SECTION 904 - NOTICE TO BIDDERS NO. 4963

SUBJECT: Quantity Corrections

Replacing 5 Bridges on SR 7 from Humphreys County Line to US 82, known as Federal Aid Project No. BR-0061-02(008) / 103327301 in Leflore County.

ADDENDUM

BY	DATE	DESIGNED	HDP	PRG	TRACED	CADD	WORKING NUMBER
JBJ	3/3/14	REVISIONS	ISSUED	NJA	DATE	1/8/14	A9 of 18
<p>MISSISSIPPI DEPARTMENT OF TRANSPORTATION BRIDGE AT STA. 478+09.21</p> <p>PROJECT BR-0061-02(008) LEFLORE COUNTY</p> <p>PLAN OF SPANS 1 & 2</p>							<p>SHEET NUMBER 8012</p>

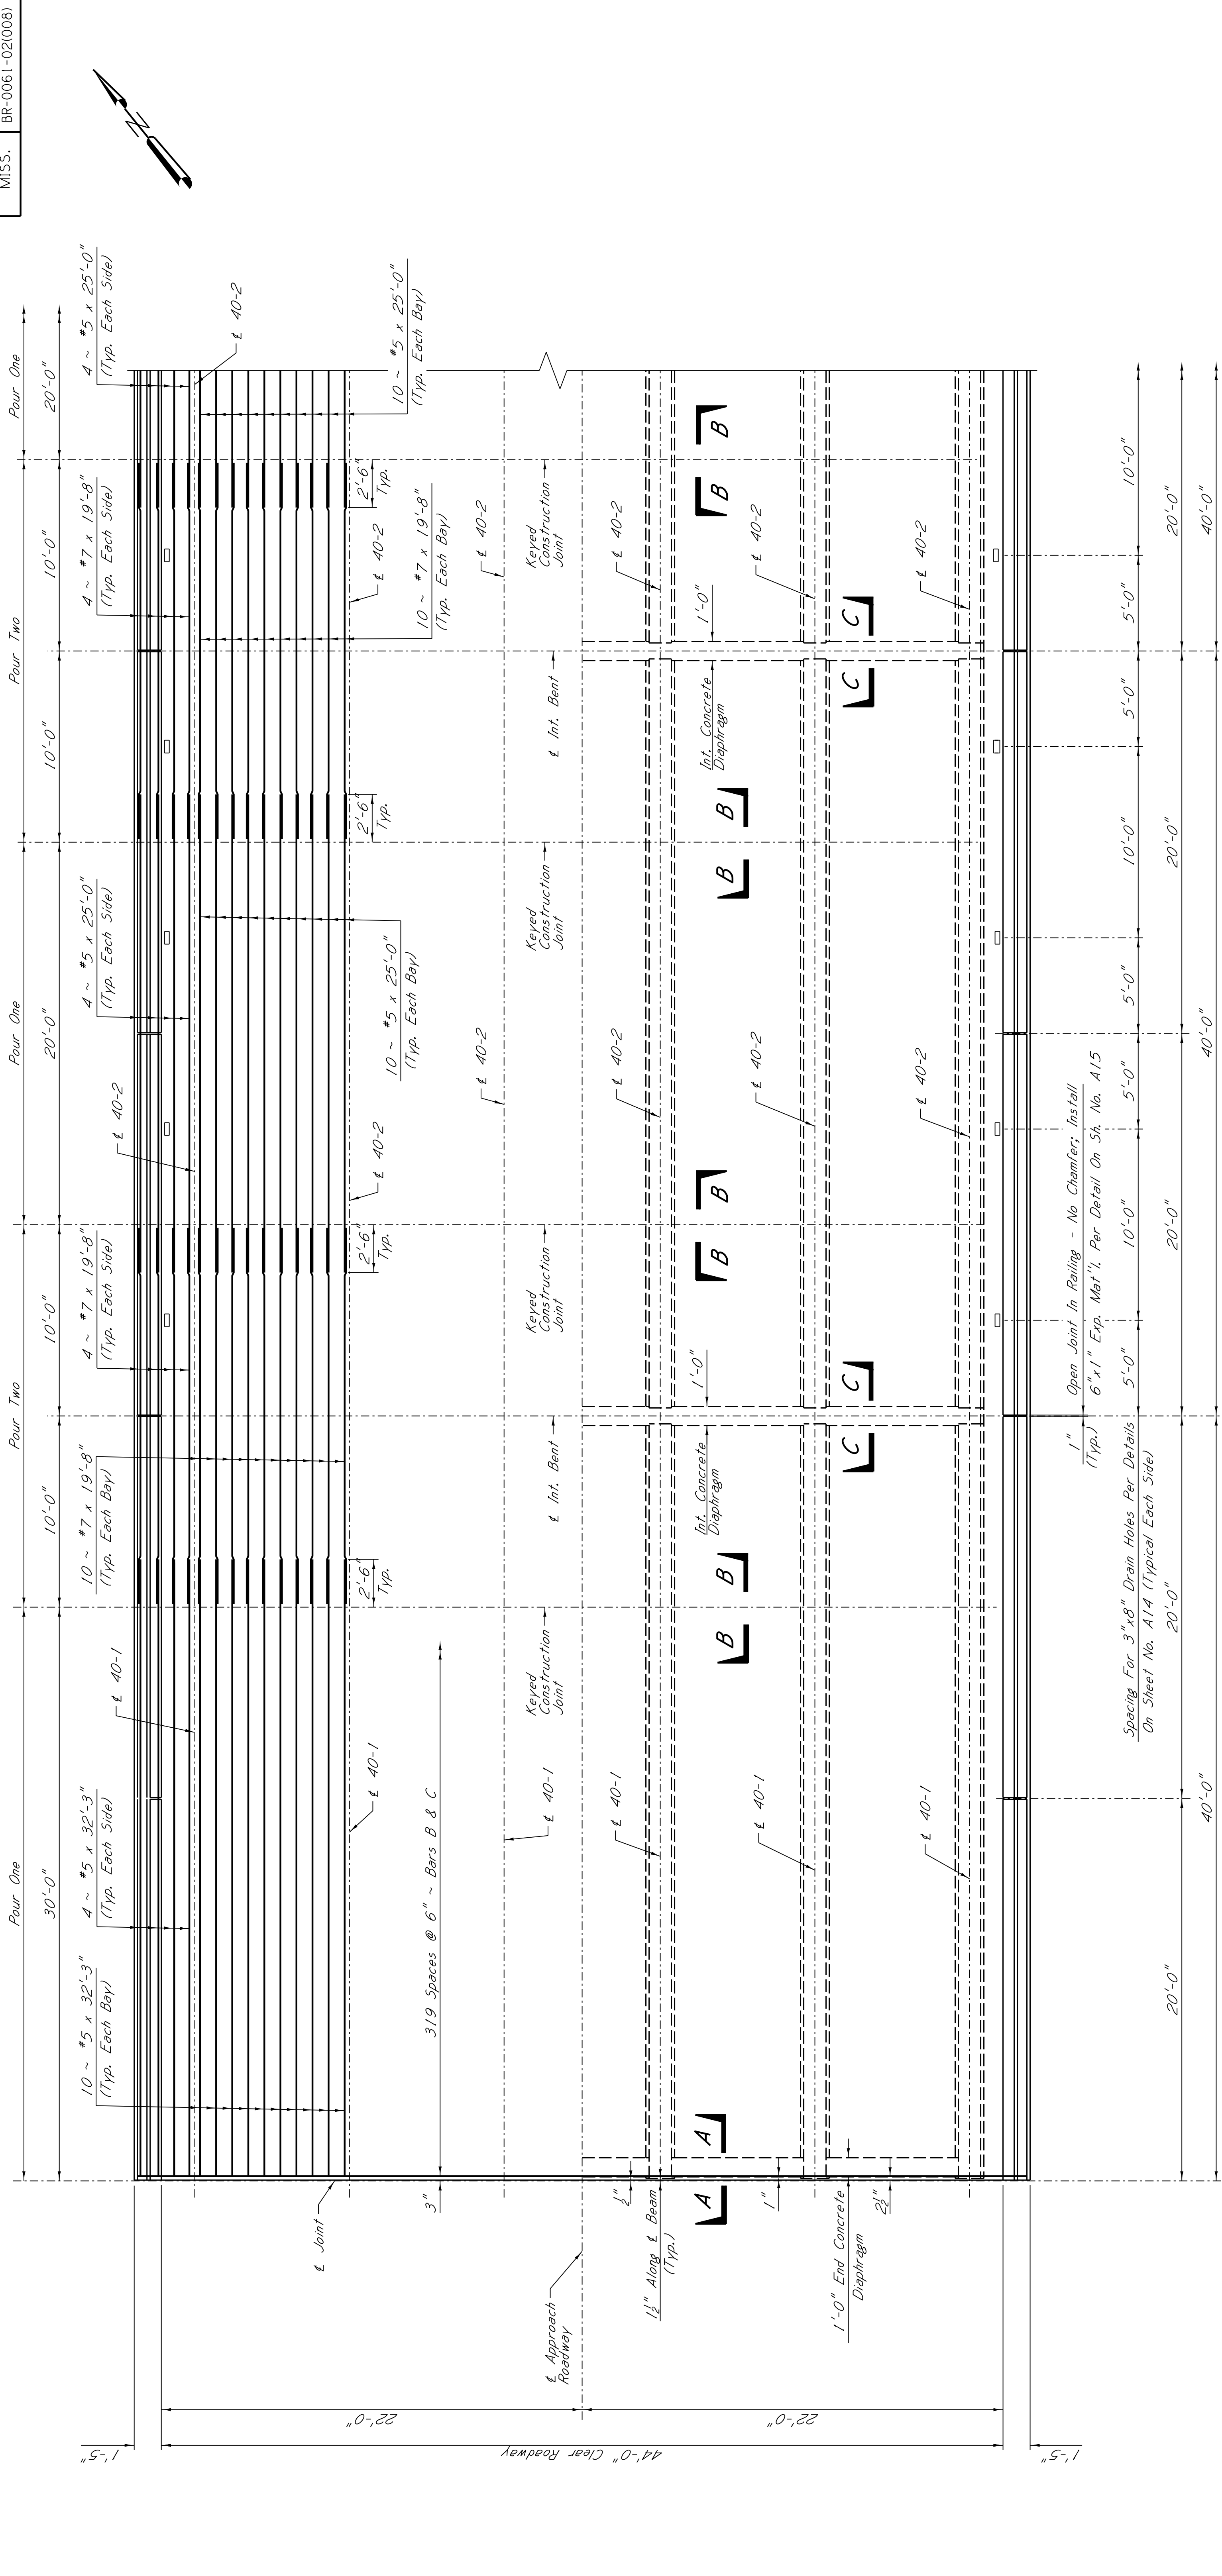
⚠ The Deck Pouring Schedule As Shown On These Plans Is Recommended And Shall Be Used Unless An Alternative Pouring Sequence Is Submitted And Approved By The Director Of Structures, State Bridge Engineer.

PLAN OF SPANS 3 & 4

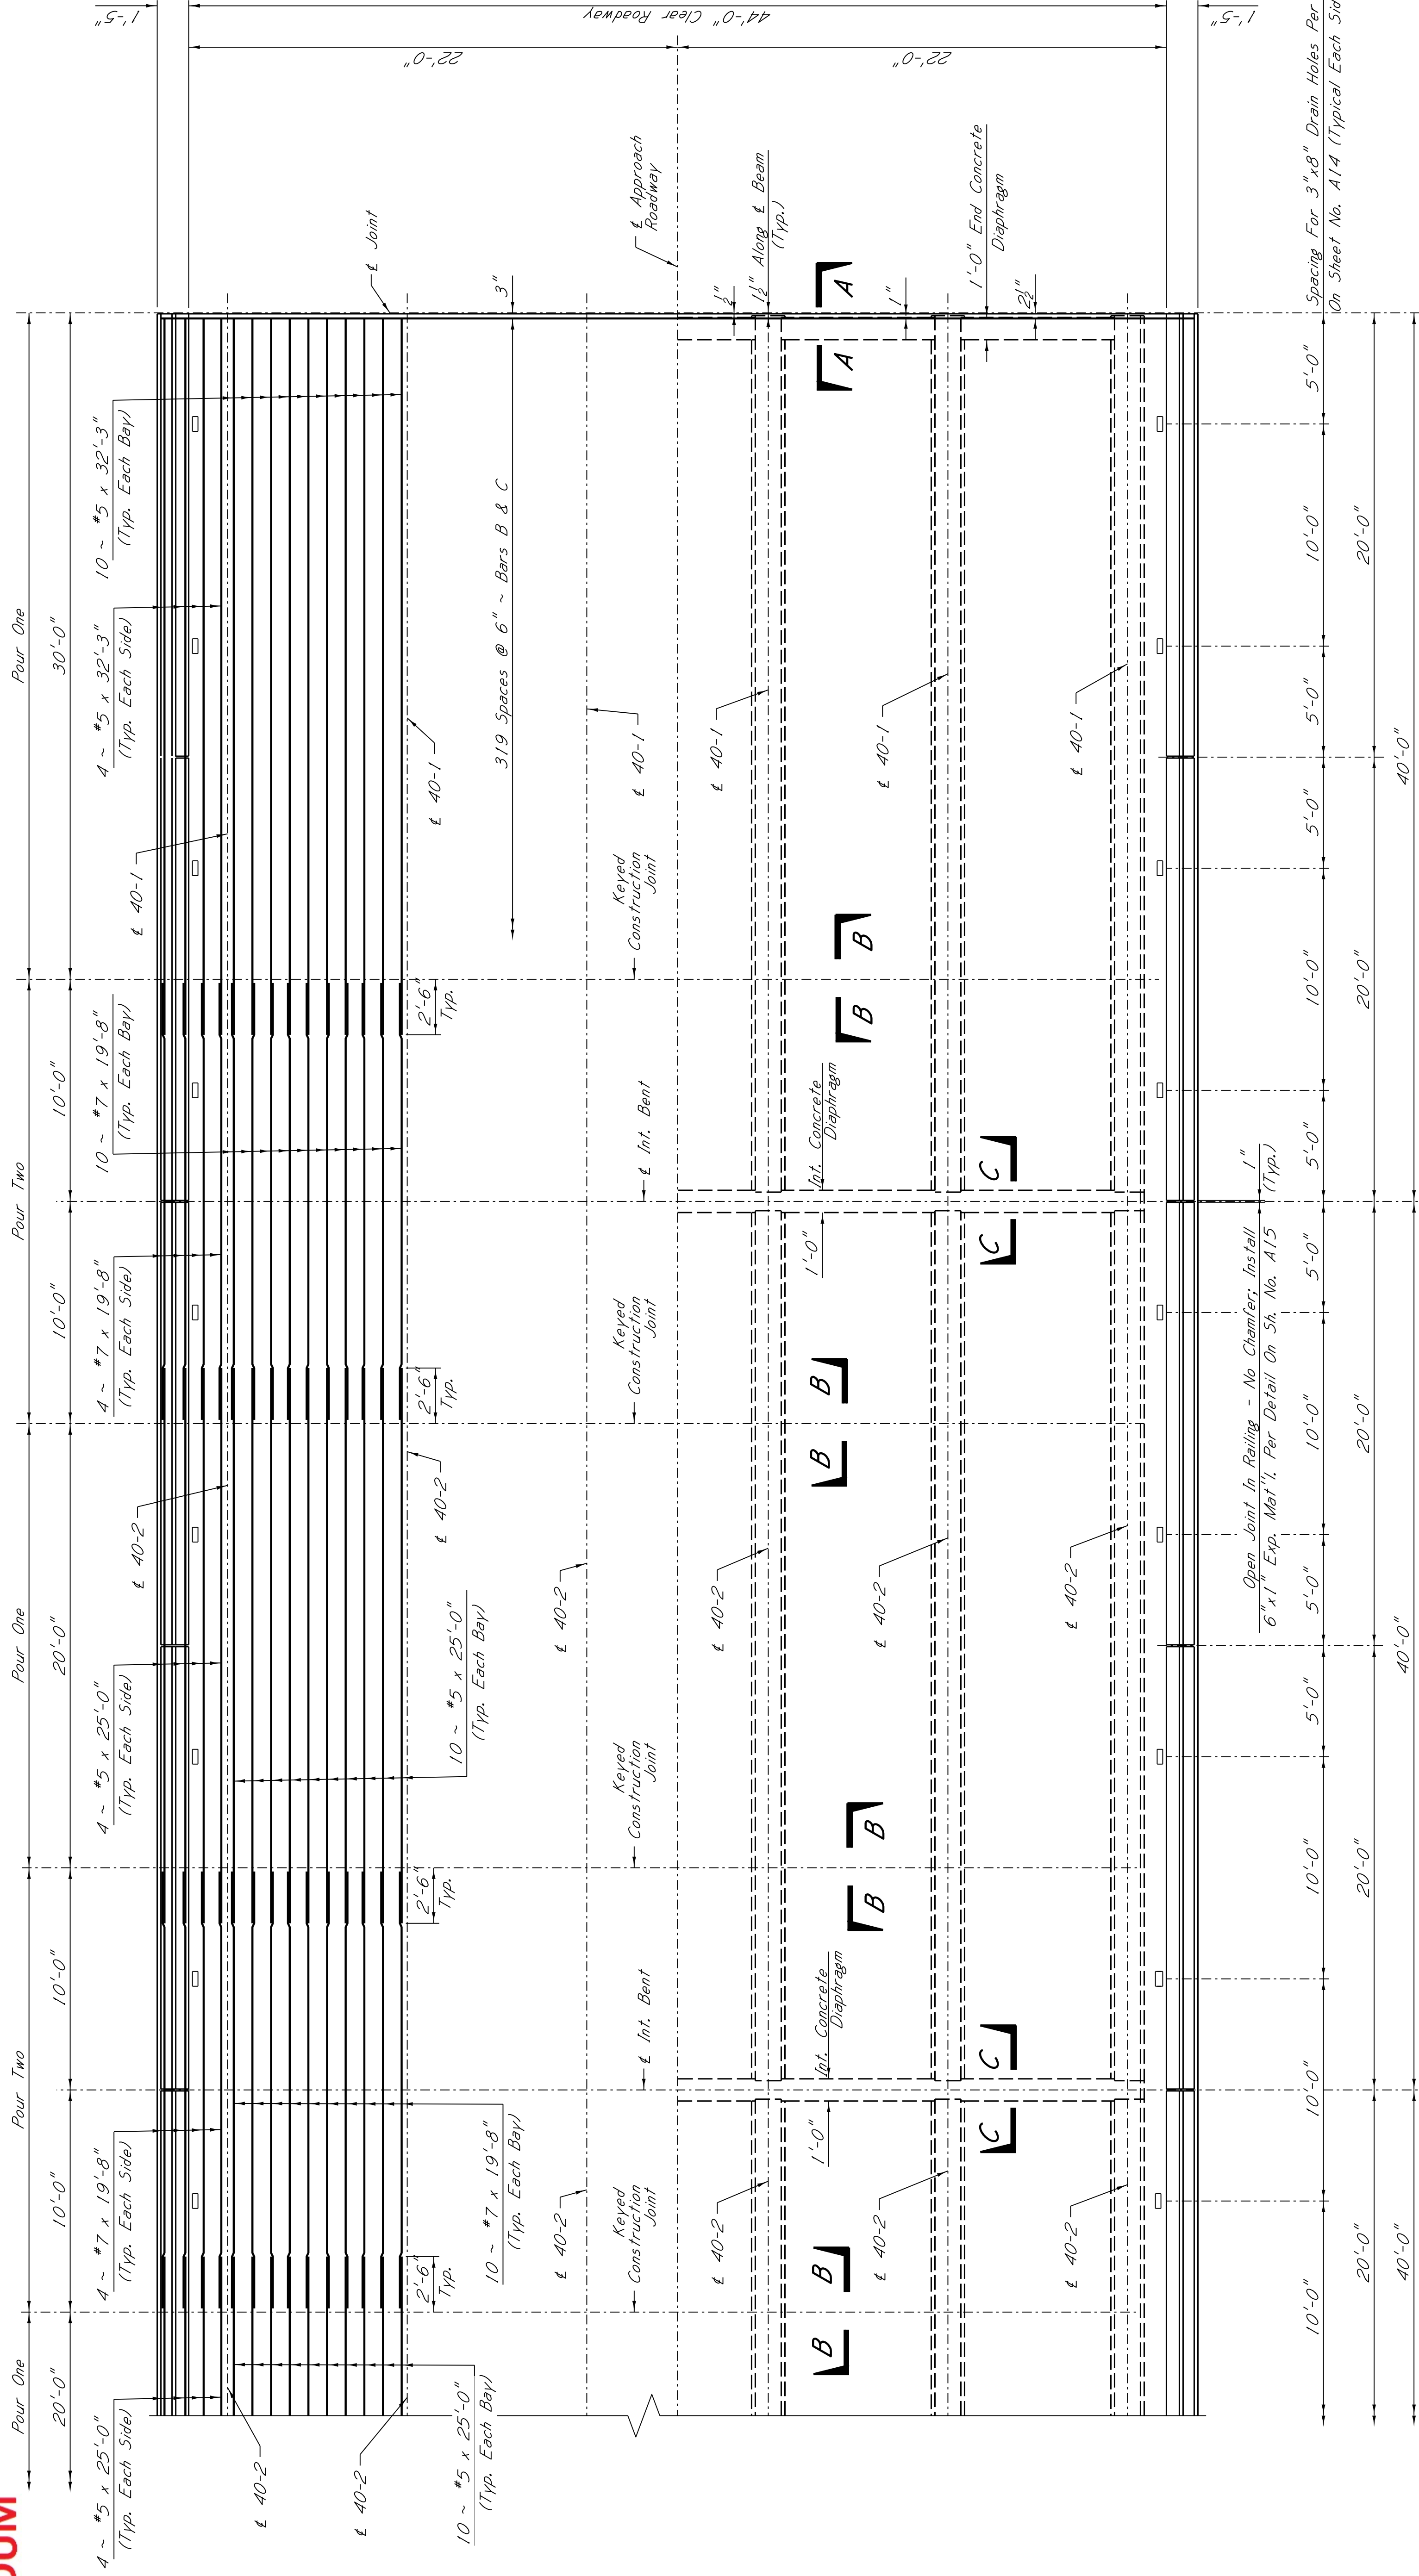
DESIGNED: HDP	TRACED: CADD	WORKING NUMBER
CHECKED: JBJ	ISSUED: N/A	A10 of 18
DATE: 3/3/14	DATE: 1/8/14	SHEET NUMBER
REVISED NOTE	DATE	8013

MISSISSIPPI DEPARTMENT OF TRANSPORTATION
BRIDGE AT STA. 478+09.21
PLAN OF SPANS 5 & 6

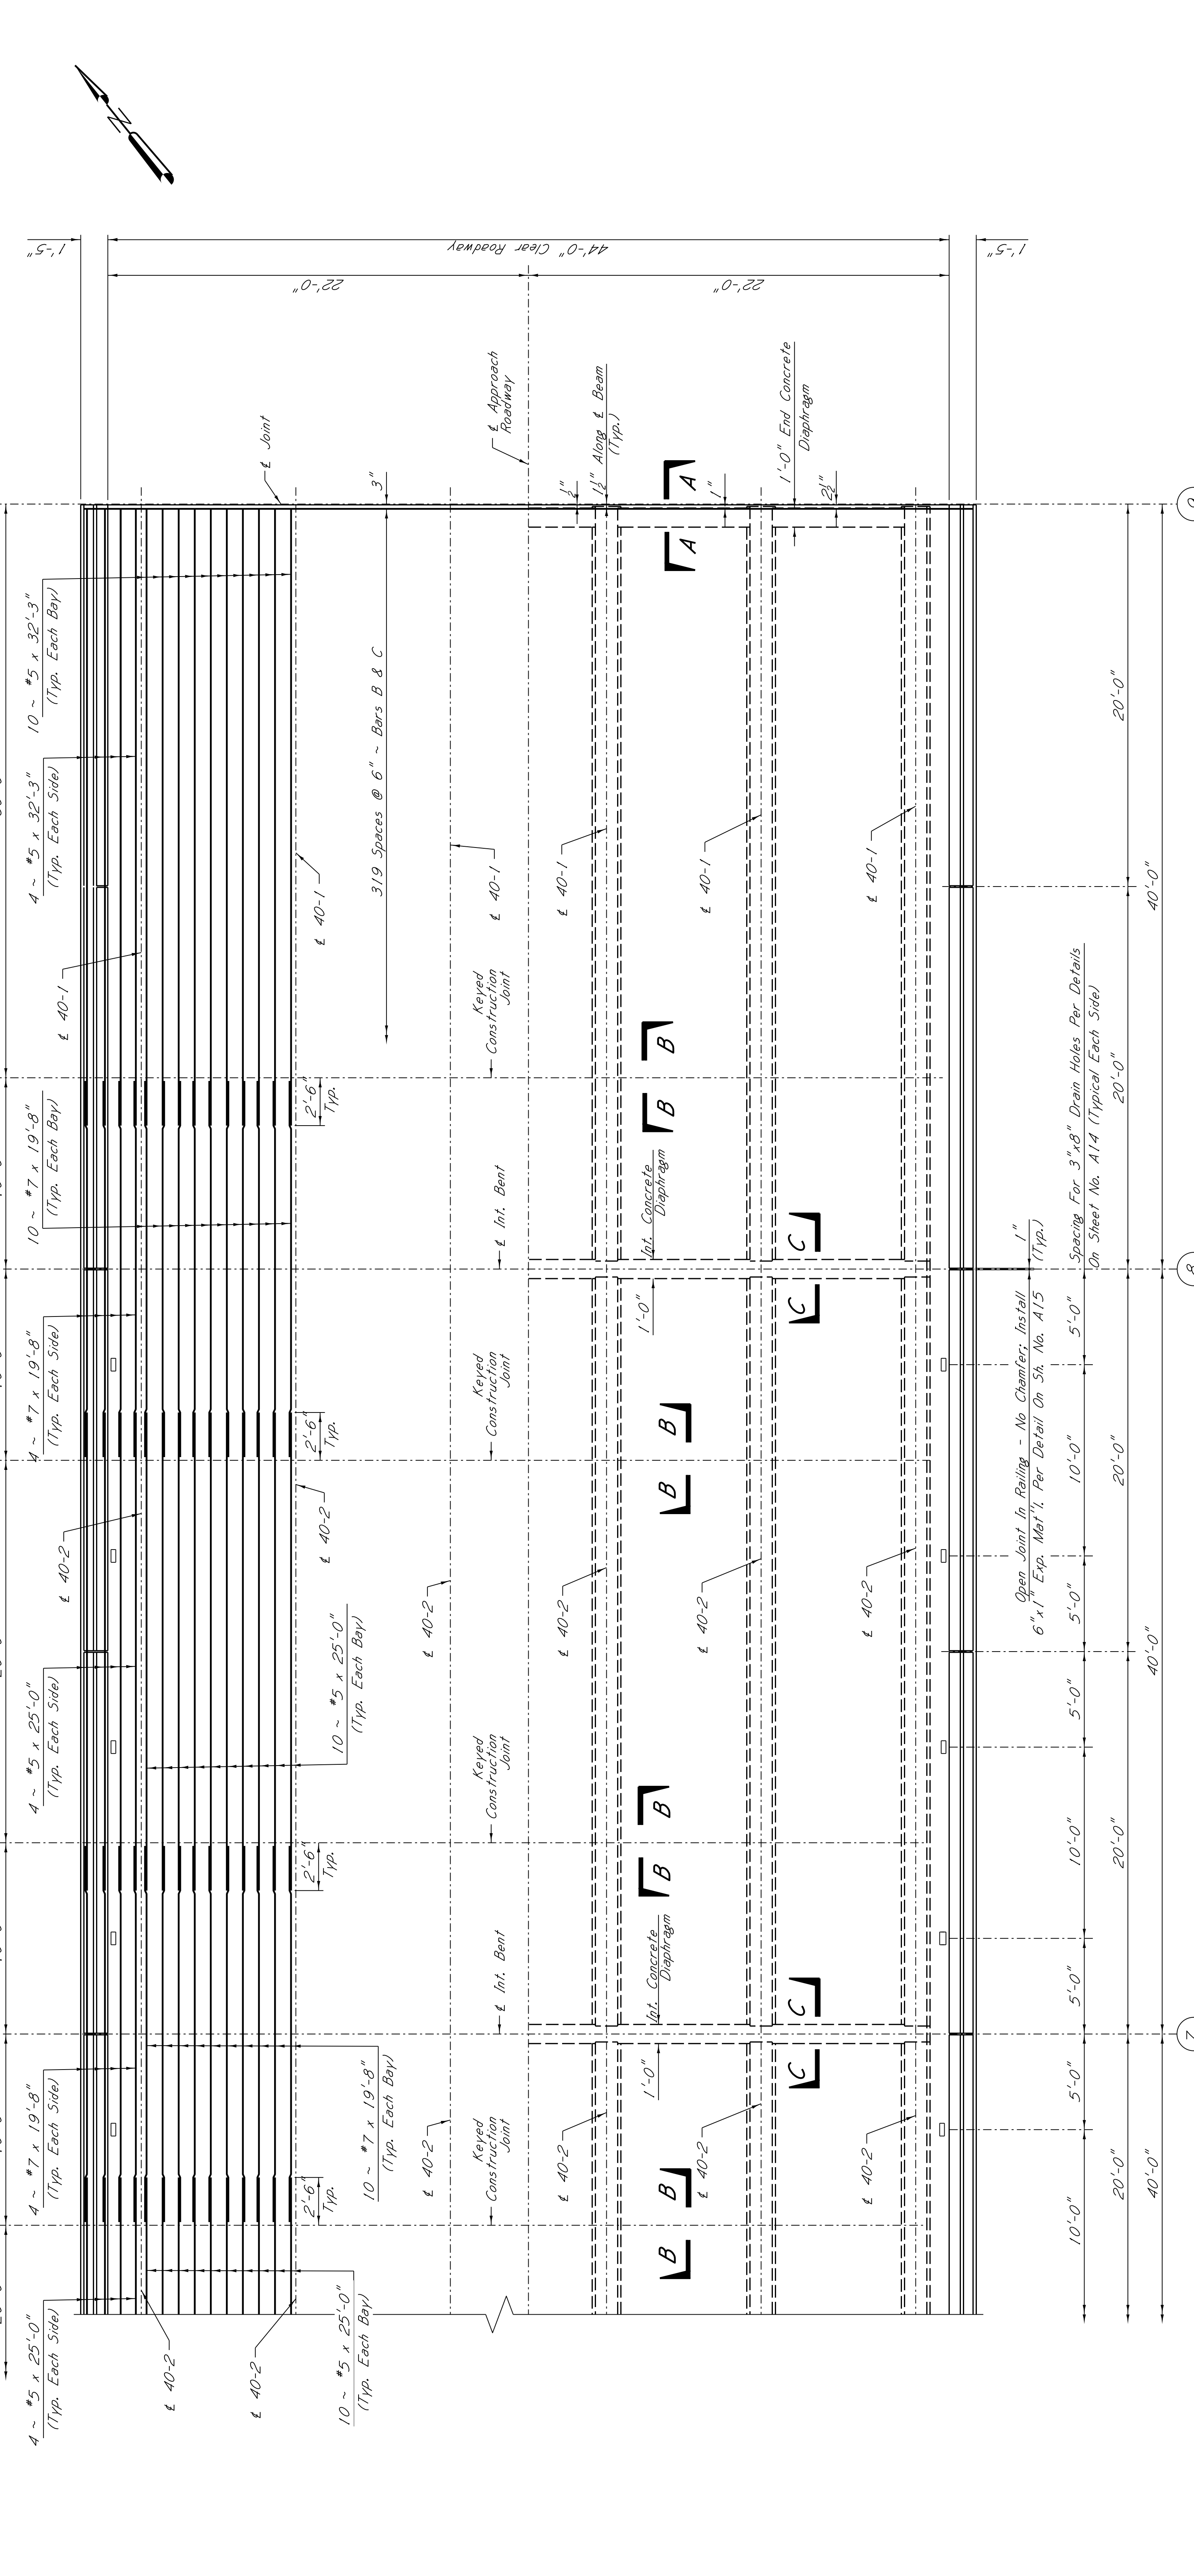
The Deck Pouring Schedule As Shown On These Plans Is Recommended And Shall Be Used Unless An Alternative Pouring Sequence Is Submitted And Approved By The Director Of Structures, State Bridge Engineer.
